TOWN OF ACTON

APPLICATION FOR PERMIT TO CONSTRUCT WITHIN A PUBLIC WAY

- 1. Permittee: George Alex. Inc Address: 572 Boston St
- 1A. Telephone #: 778-667-9667
- 2. Location of Proposed Construction: 1 Hillcrest Dr
- 3. Purpose of Construction: new driveway
- 4. Length of Cut: 7.5' approx
- 5. Width of Cut: 12'
- 6. Width of Existing Pavement: 12'
- 7. Type of Existing Roadway Surface: Paved Type of Curb: Paved
- 8. Type of Existing Sidewalk Surface: Asph Type of Shoulder: Asph
- 9. Date of Street Opening: From 11/2/02 To 11/2/02
- 10. For Work Involving Excavations: Dig Safe Number 740886

SKETCH

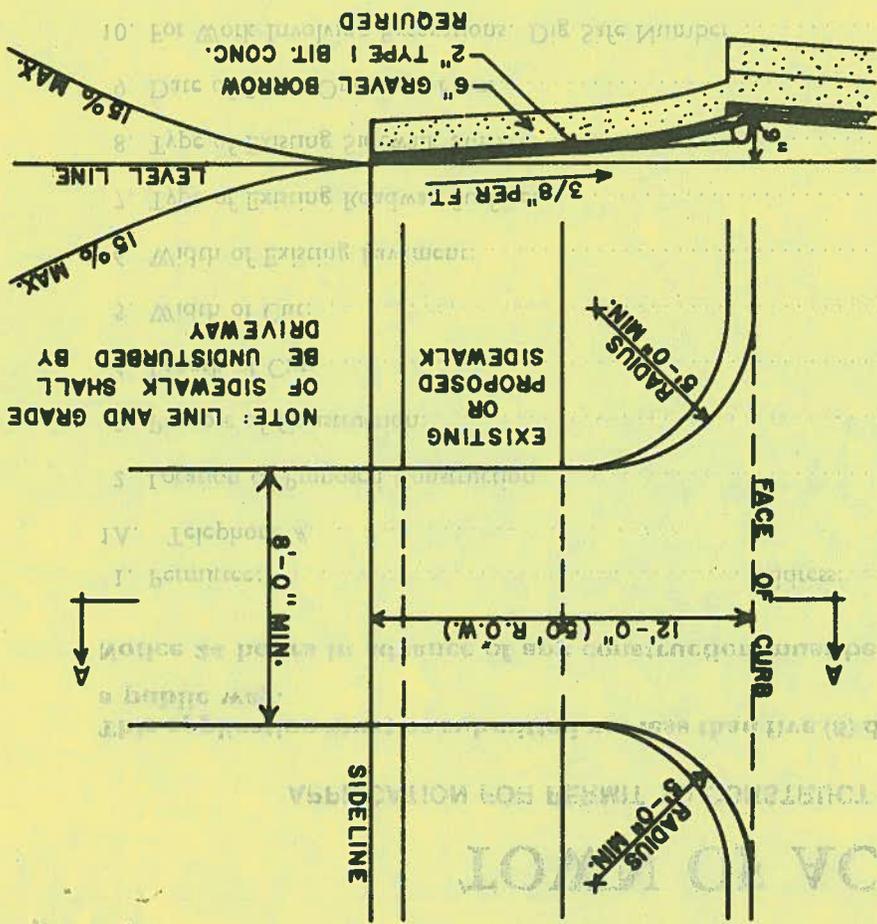
Road condition - sewer construction

see Hillcrest Dr Road layout

Road Bound at property corner by utility pole (do not disturb)

There should be an existing subline along Hillcrest

- Any foundation drain should be connected instead of discharging onto the pavement (Town Engineer EMO)

- Use caution while excavating for the driveway so that the subline is not damaged or destroyed

SKETCH

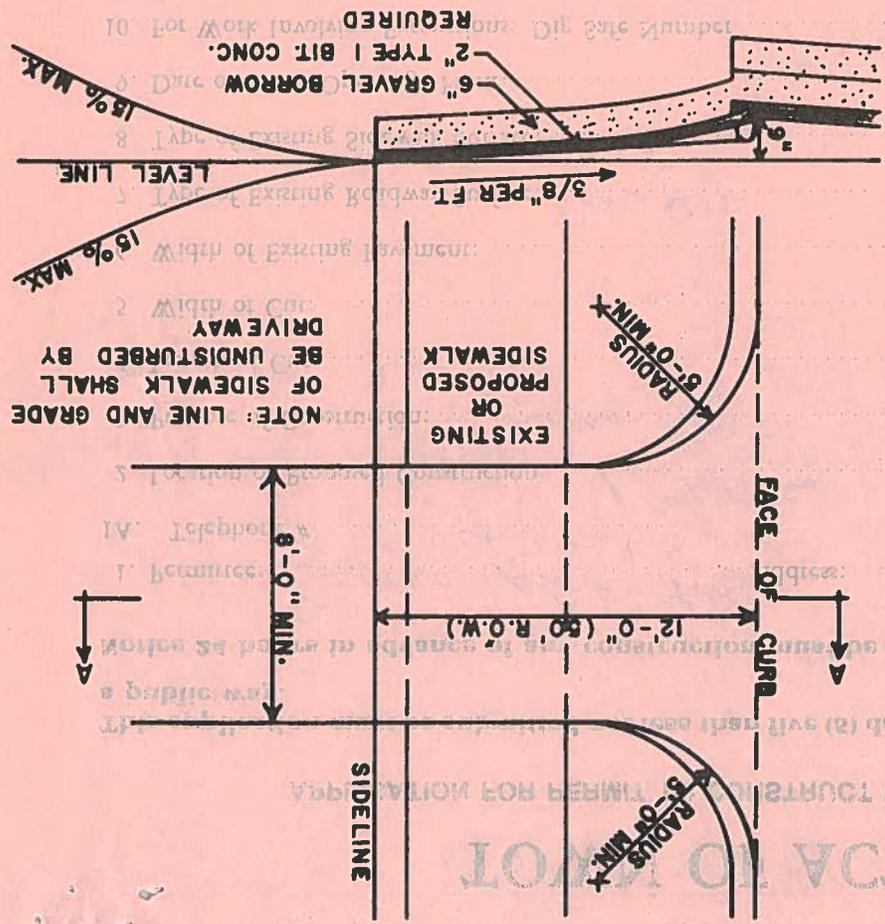
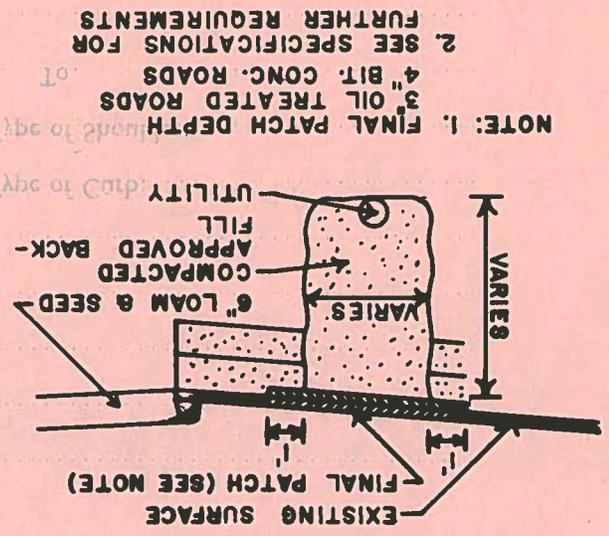
- Road condition - sewer construction see Hillcrest Dr Road layout
- Road Bound at property corner by utility pole (do not disturb) - DA, CY 9/10/02
CB/DH DK
- There should be an existing subdrain along Hillcrest
 - Any foundation drain should be connected instead of discharging onto the pavement (Town Bylaw E410)
 - Use caution while excavating for the drain so that the subdrain is not damaged or destroyed
